**Turkey Creek Regional Sewer District
Fascination Place
Water Main Improvements**

ADDENDUM 2

January 30, 2026

Plan holders on the Turkey Creek Regional Sewer District, Fascination Place Water Main Improvement, are hereby notified of the following amendments to the contract documents. This Addendum is hereby made a part of the Contract Documents.

30 of 48

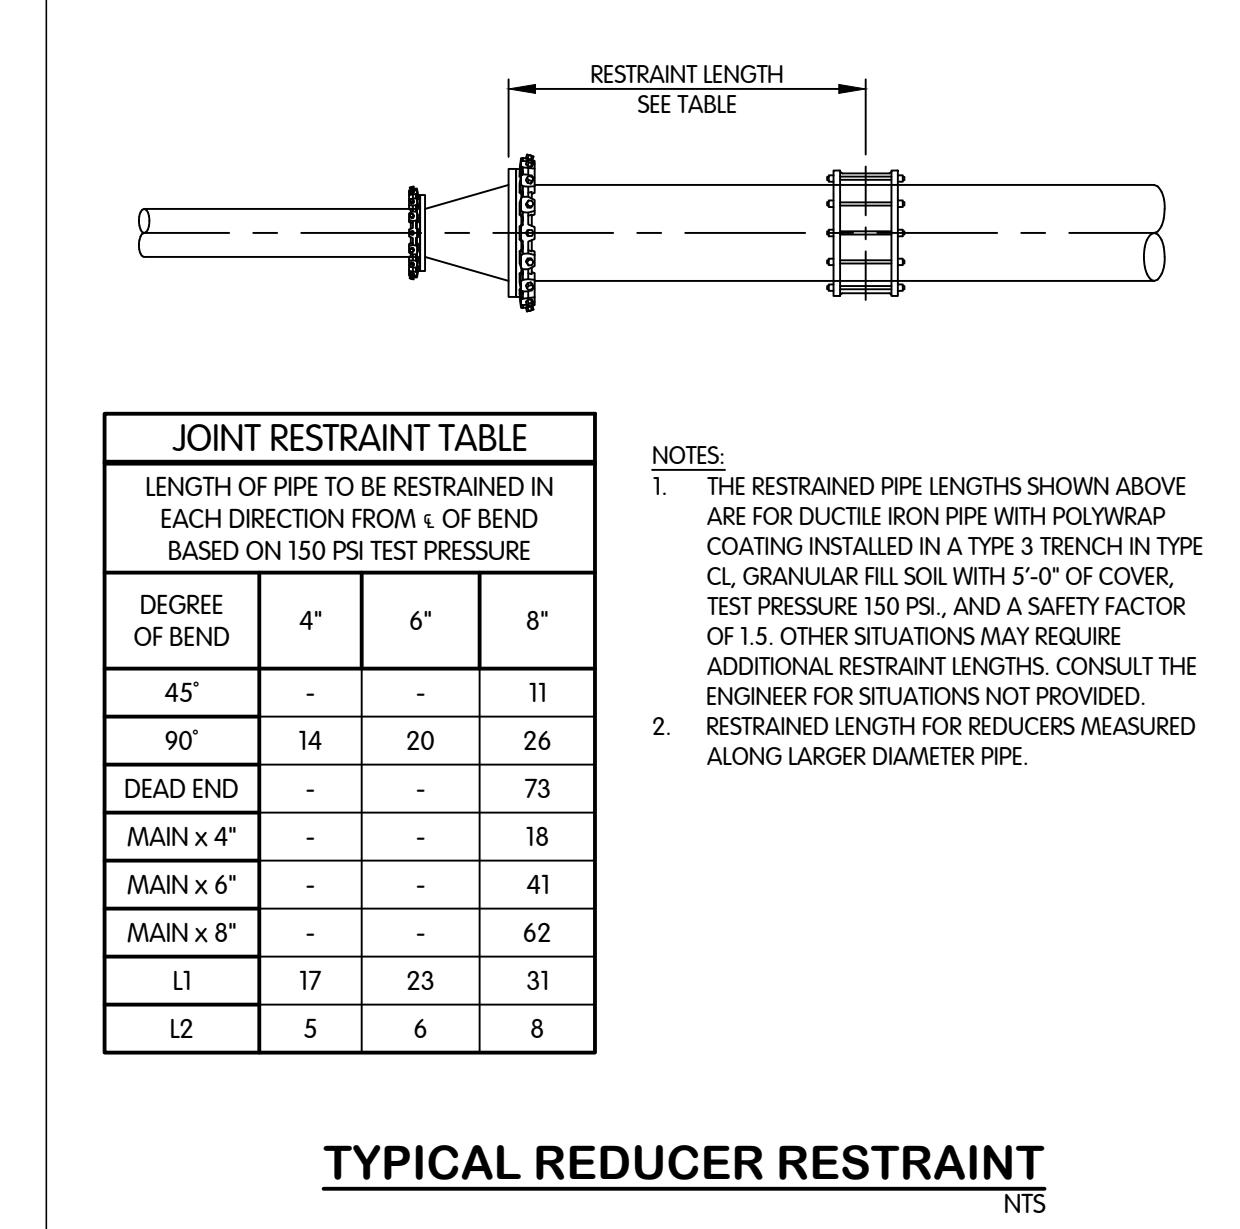
All Sheets: Delete and replace all sheets, missing logo and checked by note, added sheets G-0.5- (General Summary), & SR-0.4- (Erosion Control Narrative). Note updates sheet W-0.2.

- a. The service line can be PEXa pipe or copper per the Specification section 02558. Drawing sheet W-0.2 only states copper but PEXa is allowed. We will add this note to the drawing.
- b. The project will require erosion control. Turkey Creek RSD will apply for the SWPPP. The contractor will have to provide erosion control per the plan.
- c. Meter software setup will be through the contract. The meter supplier will need to provide meter reading services per the specifications.
- d. The contractor shall pay for the Electronic Project Management System (EMPS). It will be part of Modulization costs.
